## Engineering Change Order 0410 – Swivel Balls & U-Bolt Modules

Applies from Serial Number 2190300

Date of Change January 2019

#### 0830-03 (US Only)

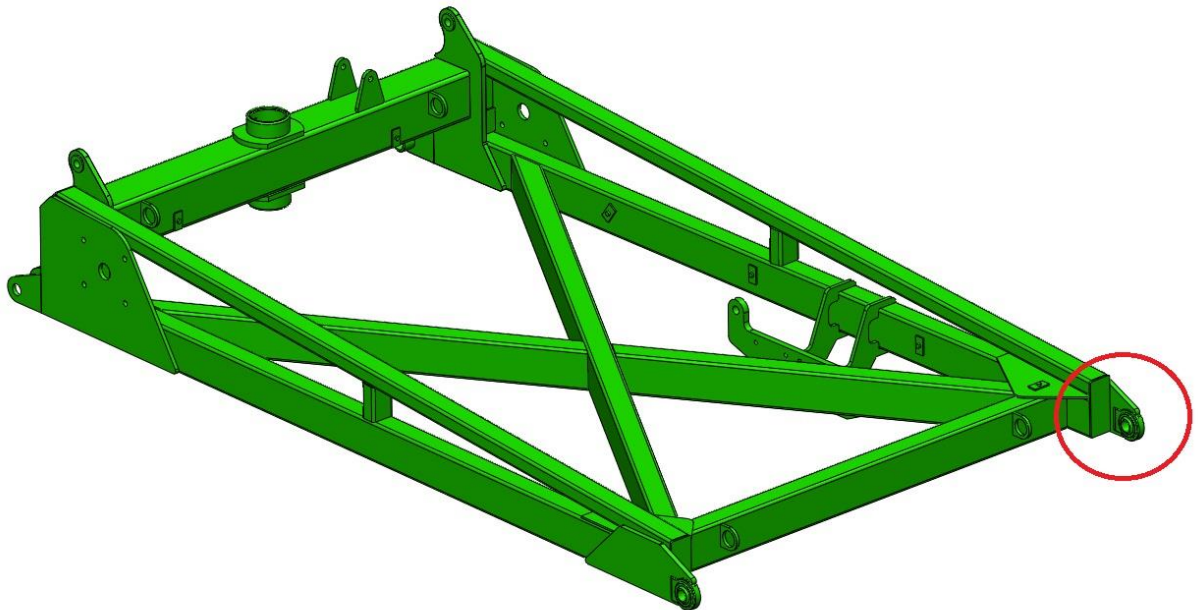
- Swivel balls added to centre frame pivot points
- Module mount plates deleted (move to u-bolt mounting of modules)

### 0830-10E (US only)

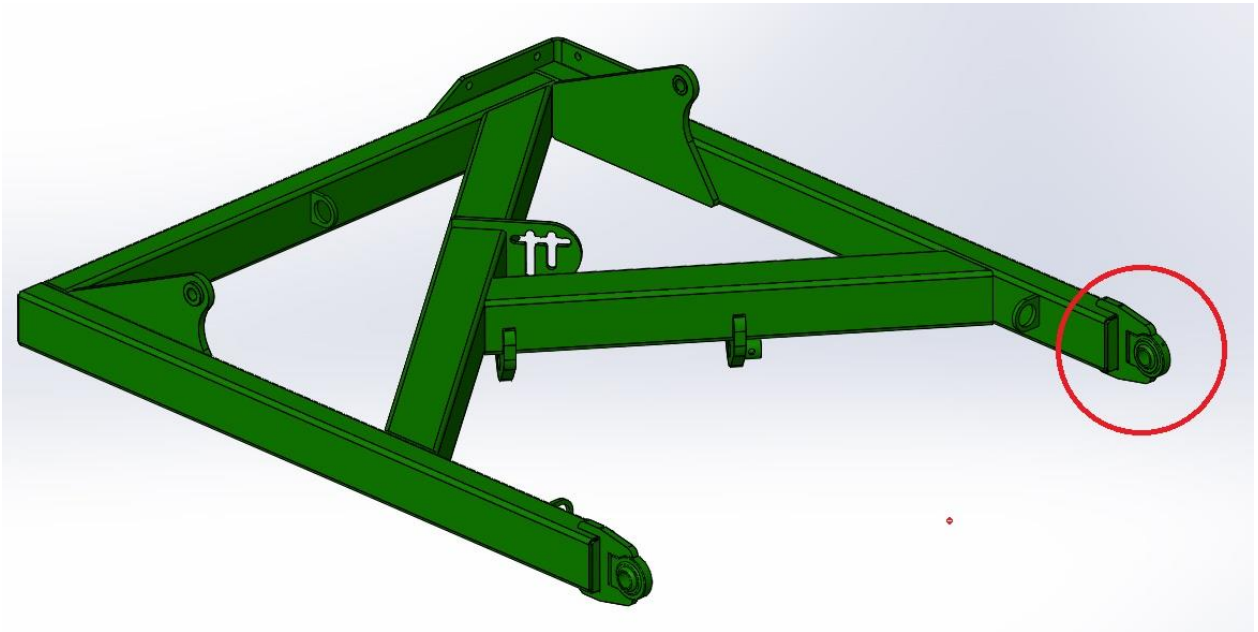
- Swivel balls added to rear A-frame pivot points

### 0810-28-30 (US only)

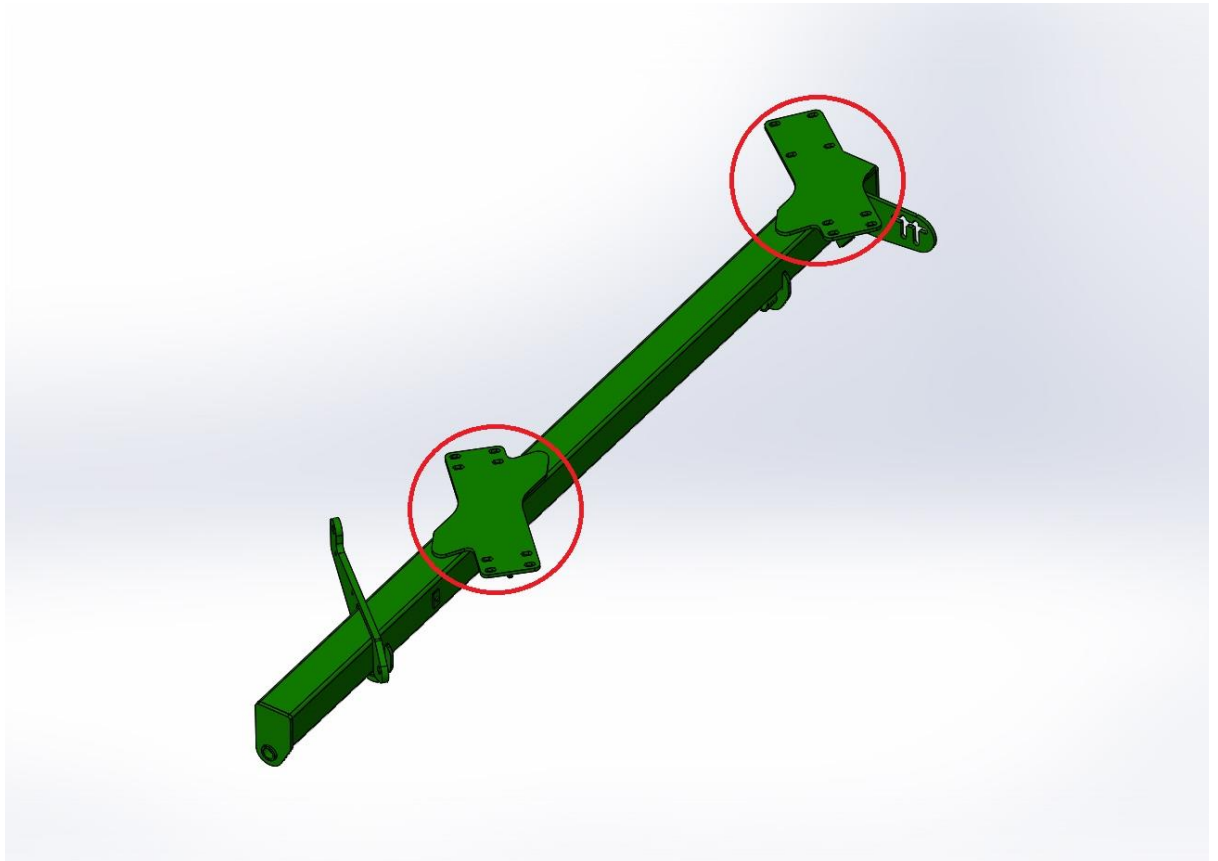
- Module mount plates modified to u-bolt configuration
- Fastener kit modified to u-bolts

### 0810-29-30 (US only)

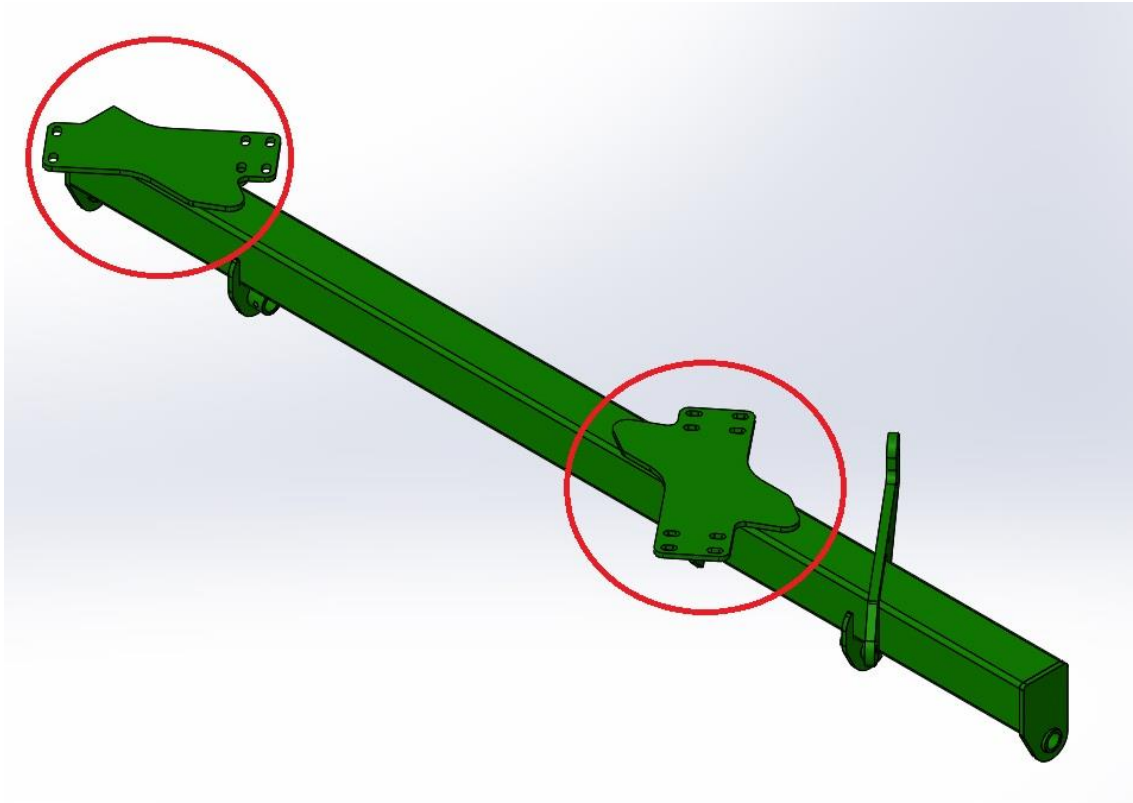
- Module mount plates modified to u-bolt configuration
- Fastener kit modified to u-bolts

1646-03-1

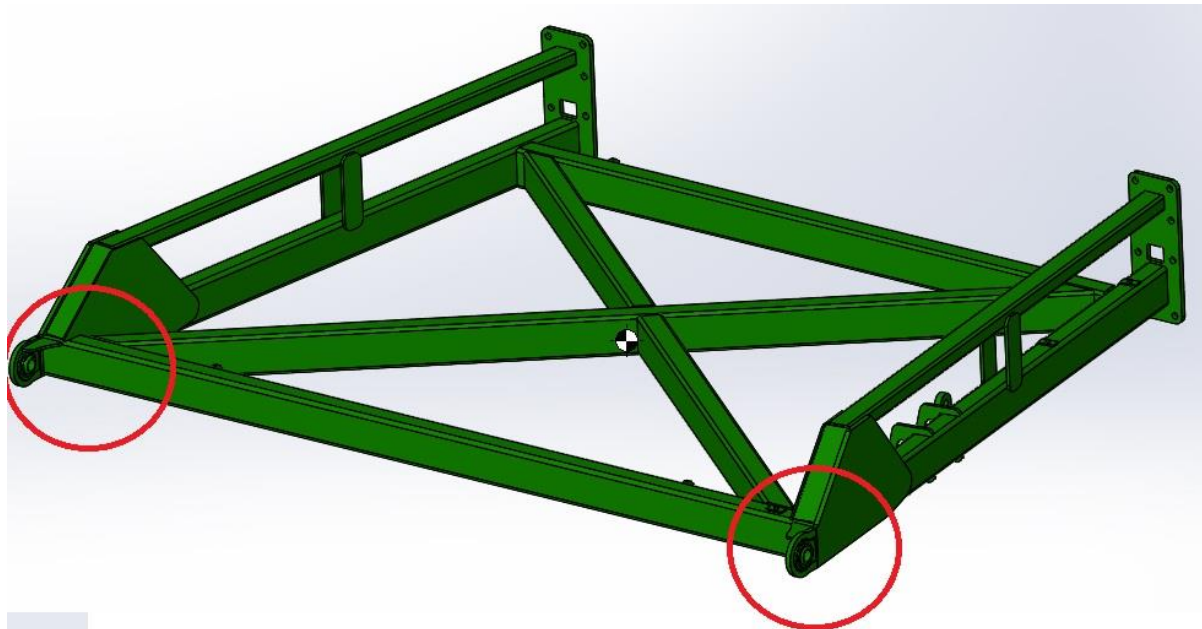
- Swivel balls added to centre frame pivot points

### 1610-10S-REM

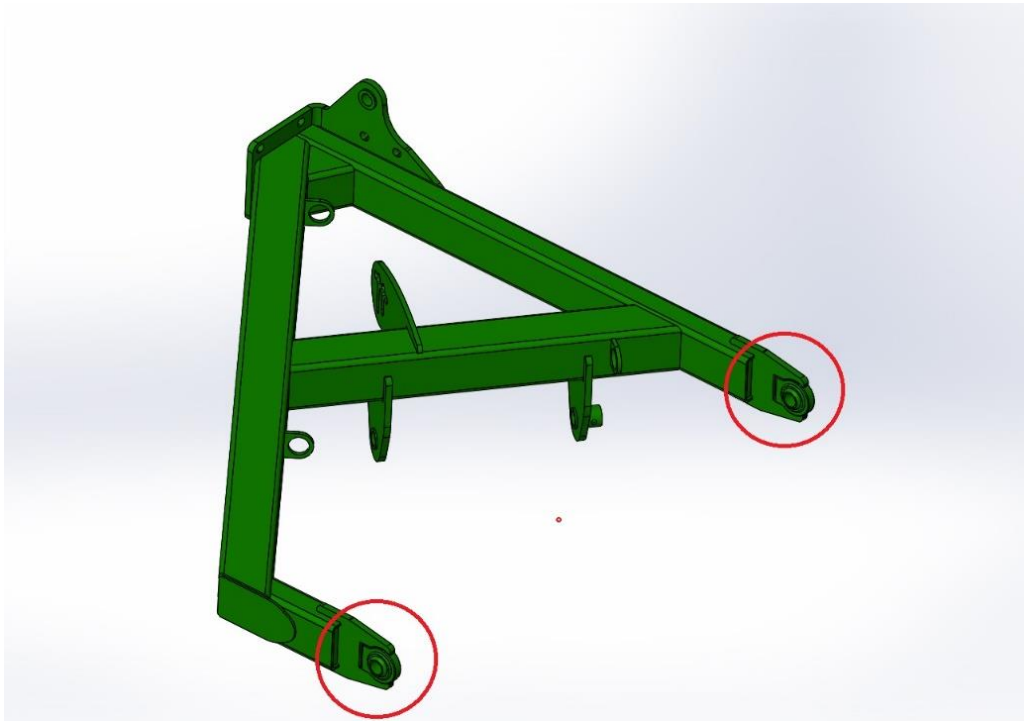
- Swivel balls added to rear A-frame pivot points
